Department of Conservation and Development

STAFF REPORT

Project Title:	Appeal of Zoning Administrator Approval of New Single-Family Residence in Kensington
County File(s):	#DP15-3030
Appellants	George and Anita Luk (153 Lawson Road, Kensington); Edward Dean and Darlene Tong
Applicants/Owners:	Edward Dean and Darlene Tong
Zoning/General Plan:	Kensington Combining District (-K), Single-Family Residential District (R-6), and Tree Obstruction of Views Combining District (-TOV) / Single-Family Residential High-Density (SH)
Site Address/Location:	Vacant lot at the end of Lawson Road, Kensington; (APN: 572-034-018)
California Environmental Quality Act (CEQA) Status:	Exempt under CEQA Guidelines, Section 15303(a), regarding new construction or conversion of small structures.
Project Planner:	Dominique Vogelpohl, Planner I (925) 674-7814
Staff Recommendation:	Deny appeals, and uphold the Zoning Administrator's decision (See section II for full recommendation)

EXHIBIT 1
SOUTH VIEWS

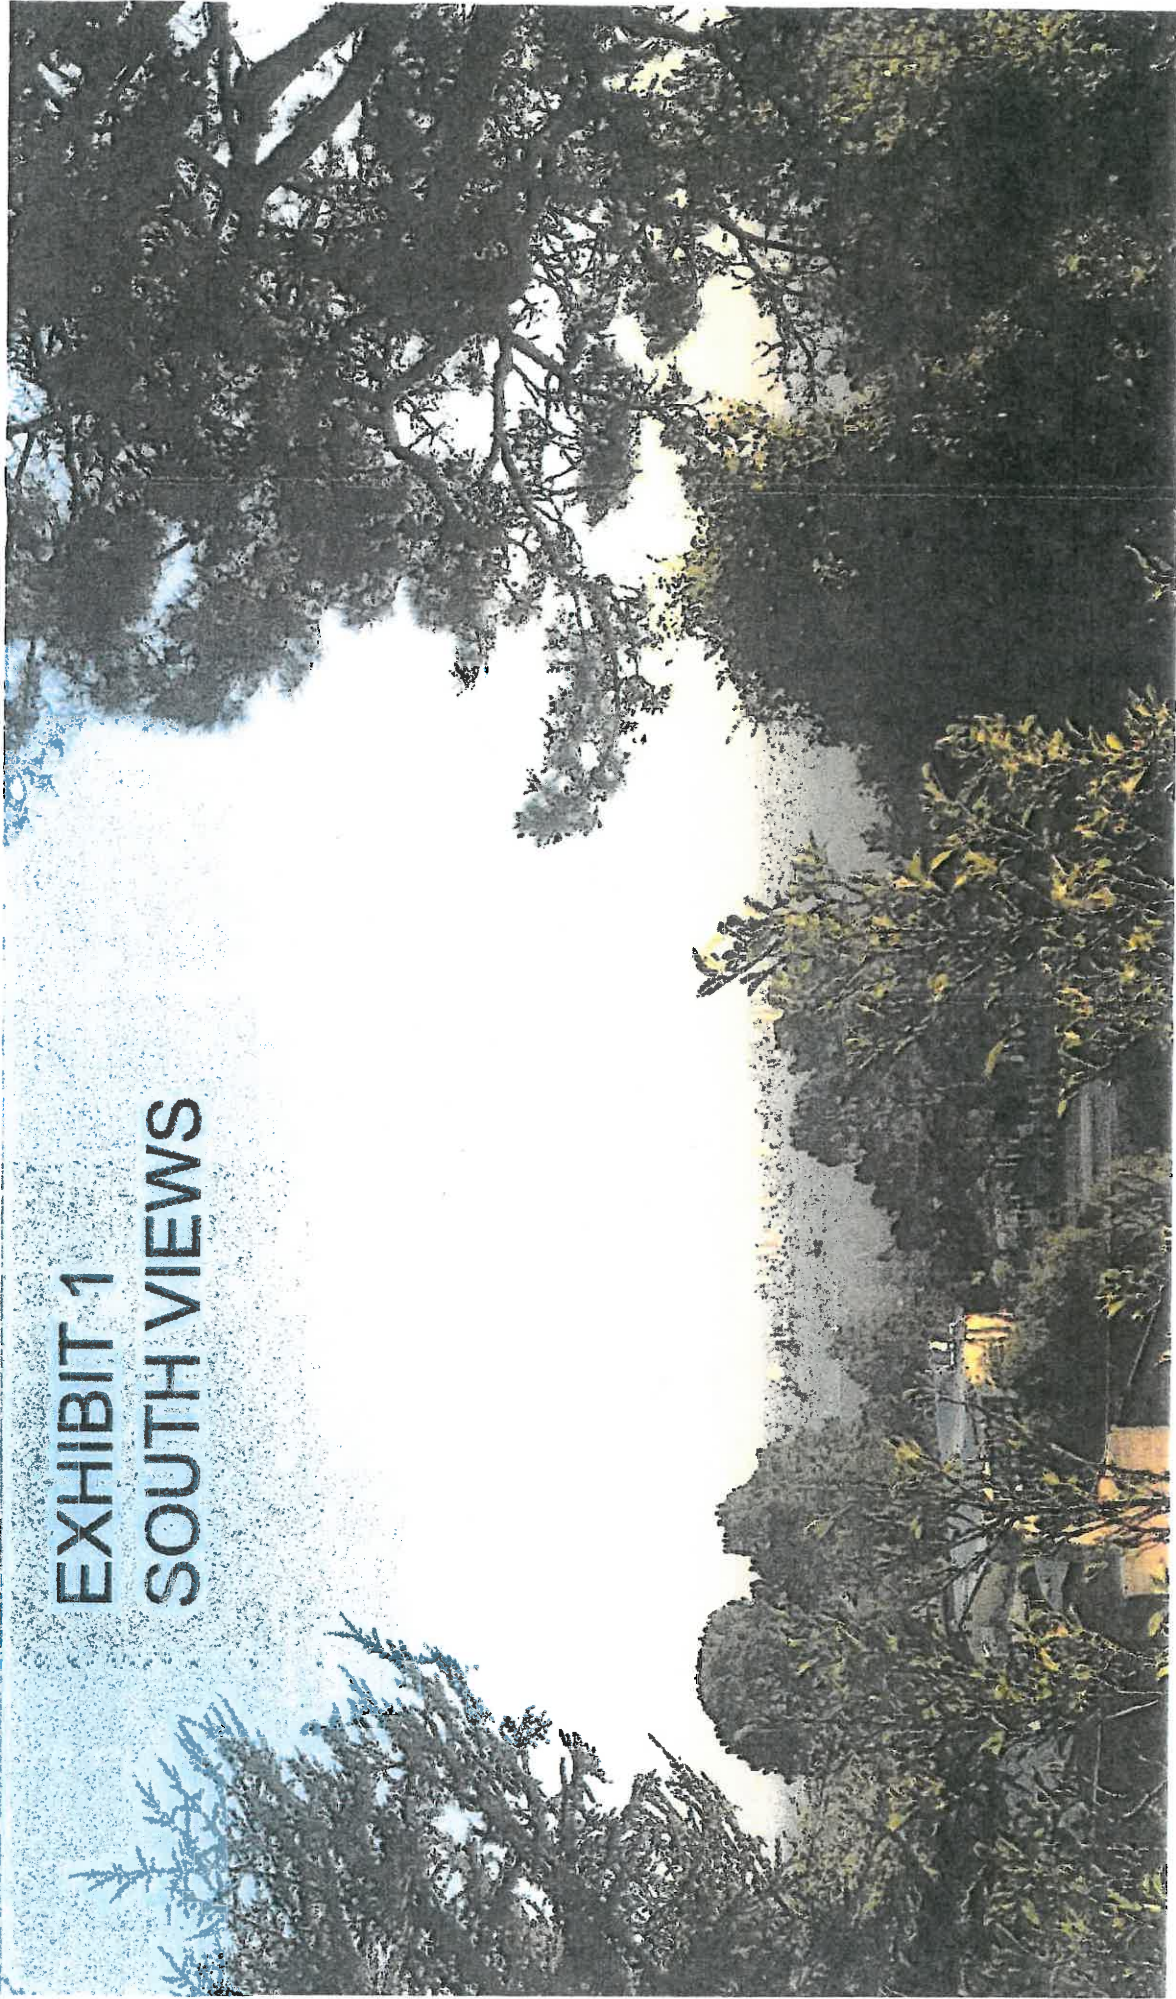
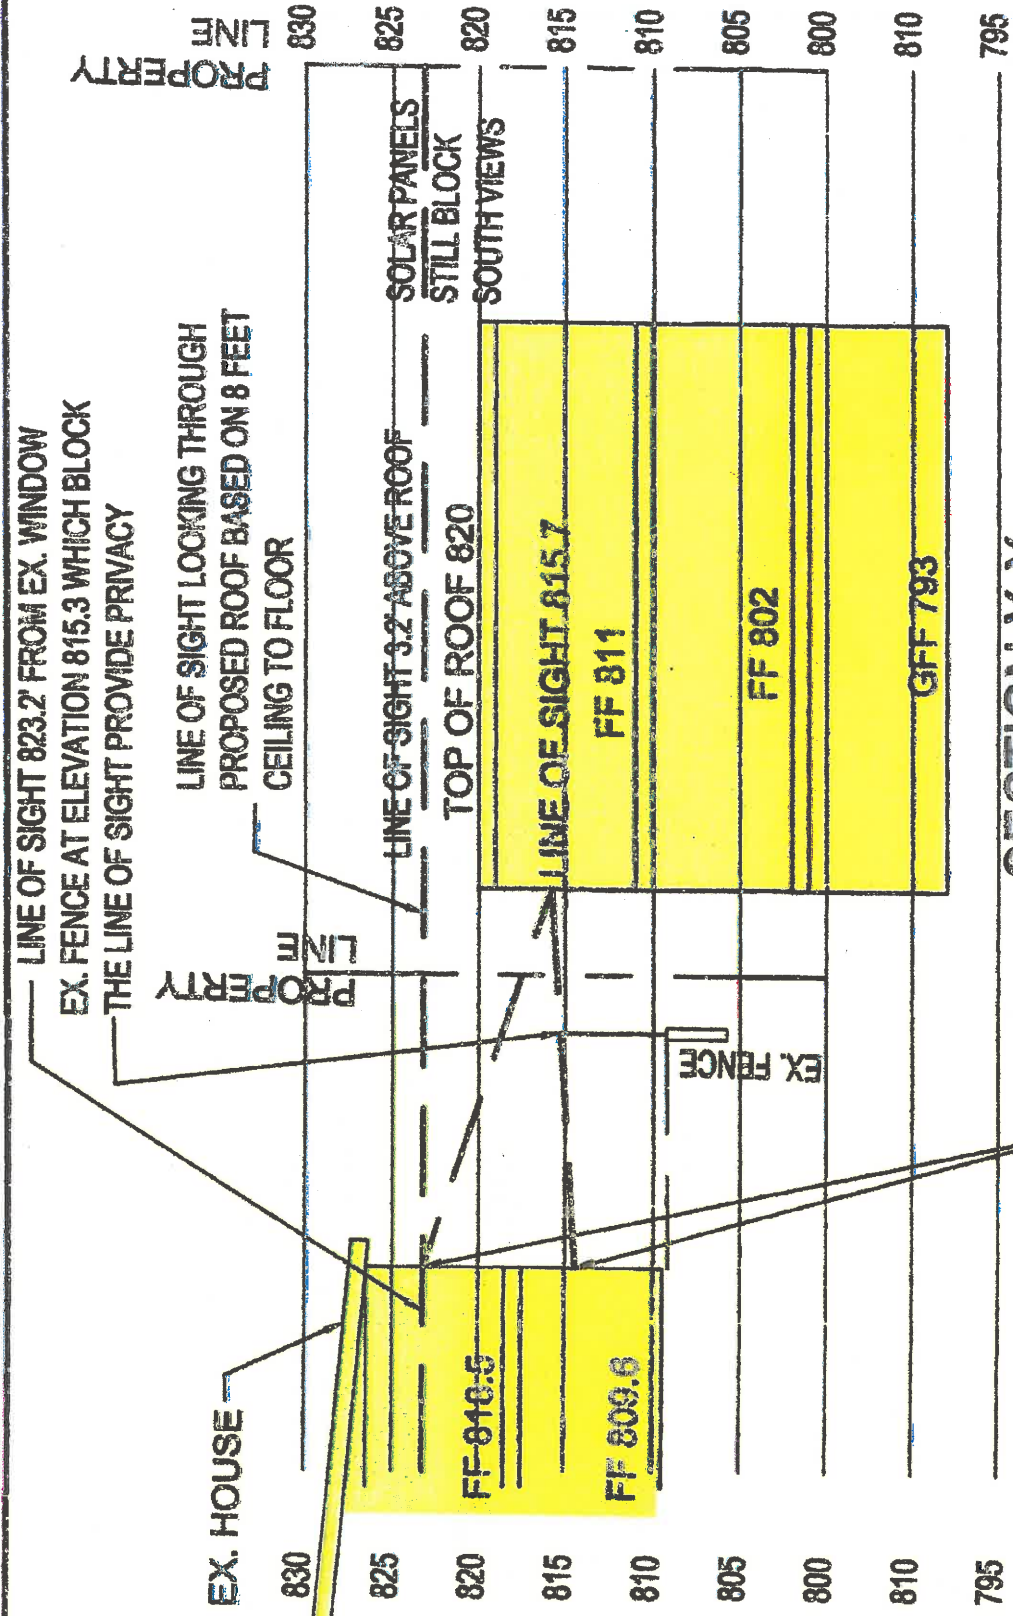
As evidence of this non-promotion, Exhibit A-1 of Section X-X as shown on Luk's comments within the staff report shows how the planned house height, being almost the same as that of neighboring 153 Lawson Road, will completely block the line of sight from 153 Lawson Road. The current line of sight includes views of the distant cities of Berkeley, Emeryville, Oakland and South San Francisco Bay as clearly shown in the attached photo submitted as Exhibit 1 South Views on Luk's comments within the staff report. This picture reflects the clear panoramic view in the background looking south. The staff report denied the existence of this view, and instead picked an image of a foggy day, where views cannot be seen of the distant cities of Berkeley, Emeryville, Oakland and South San Francisco Bay.
